## DISCUSSION

### Seismic evaluation of grouted splice sleeve connections for reinforced precast concrete column-to-cap beam joints in accelerated bridge construction

**Figure 19.** Normalized curvature distribution. Note:  $F$  = force;  $P$  = axial load.

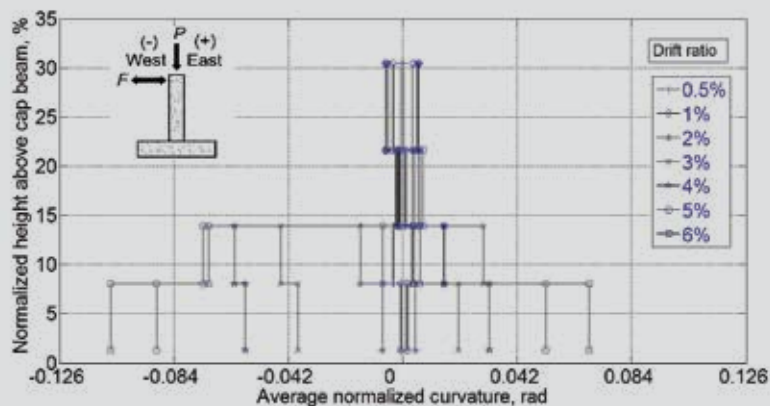
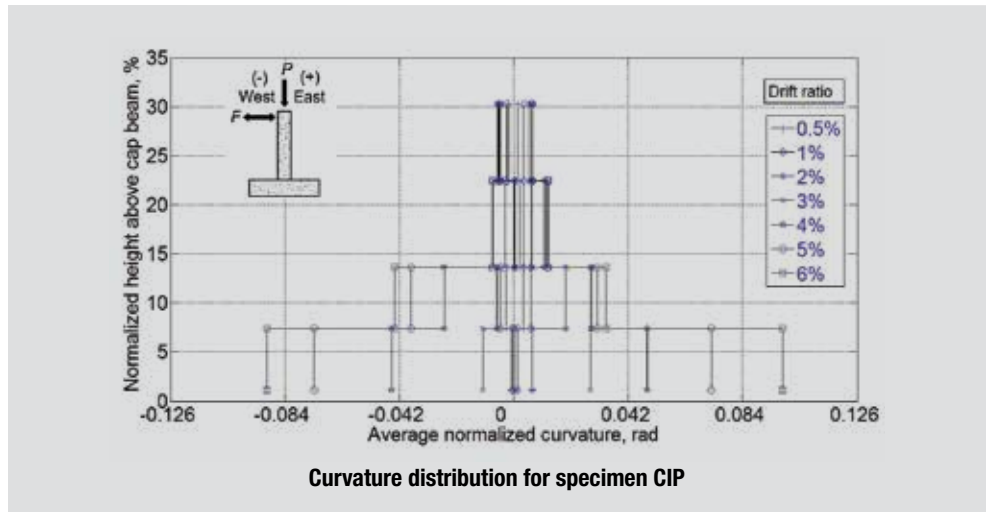
Equation (2) on page 97,  $\phi = \frac{A-B}{wh}$ , and Fig. 19 on page 98 of “Seismic Evaluation of Grouted Splice Sleeve Connections for Reinforced Precast Concrete Column-to-Cap Beam Joints in Accelerated Bridge Construction”<sup>1</sup> by M. J. Ameli, Joel E. Parks, Dylan N. Brown, and Chris P. Pantelides in the March–April 2015 issue of *PCI Journal* may need some clarification. As I read the equation, the units on curvature should be rad/inch. The width of curvature segment  $w$  is probably the distance between the linear variable differential transformers rather than the column thickness. The second sentence below the equation, “The average curvature values were normalized by multiplying by the column dimension of 21 in. (530 mm), and the curvature segment heights were divided by the overall column height of 96 in. (2440 mm),” does not make sense to me. Something seems to have been omitted in the description.

The authors appreciate Bill Gamble's comment. The authors would like to point out that Eq. (2) on page 97 defines the average curvature values, whereas Fig. 19 on page 98 presents the average normalized curvature values.<sup>1</sup> In the second sentence following Eq. (2), the authors explained the normalization method, which was conducted as follows: the values obtained from Eq. (2) were multiplied by the column dimension of 21 in. (530 mm). The width of curvature segment  $w$  is indeed the distance between linear variable differential transformers. This was an effort to simplify the curvature distribution plots in a dimensionless form.
